INDIANA HARBOR BELT RAILROAD COMPANY

BULLETIN ORDER NO. S-43  
Effective: 0600 Sunday October 6, 2024

October 4, 2024  
General Orders in effect: NONE

**26. GIBSON YARD – PHYSICAL CHARACTERISTIC CHANGES – MODIFIED 7/7/2023:**

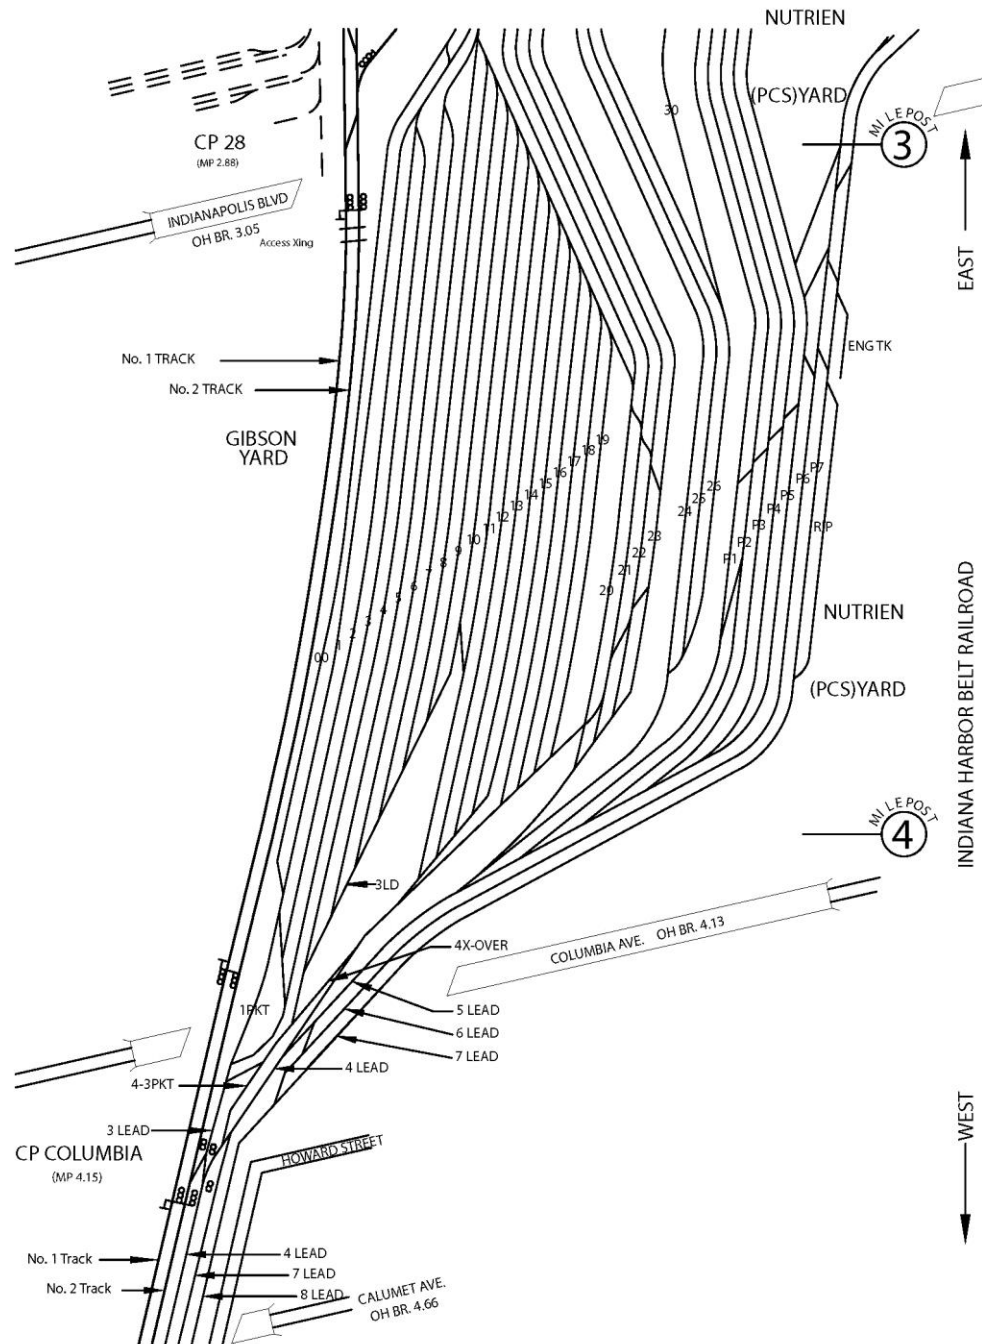
Effective 0600 6/21/2023, employees must make a note on page 20 of IHB Timetable No. 3 “See bulletin changes dated 7/7/2023” and keep a copy of new map in their possession. Foreign line crews must make the same note on Page IHB-59.

On the next page is a map of the revised configuration:

**55. GIBSON YARD MAP- MODIFIED 5/28/2022:**

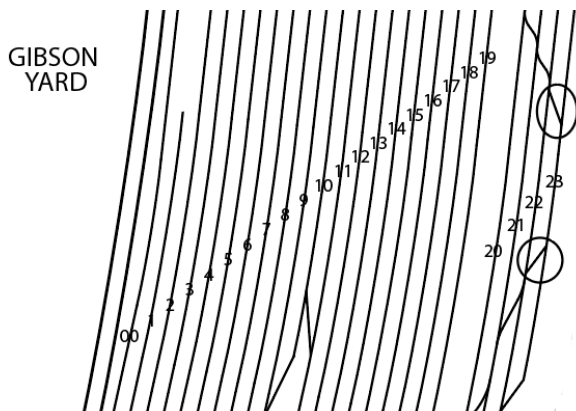
Effective 0600 5/28/2022, employees must add the two crossover switches from track 22 to track 23 (circled in the image below) in ink on page 20 of IHB Timetable No. 3. Foreign line crews must make the same modifications to Page IHB-59:
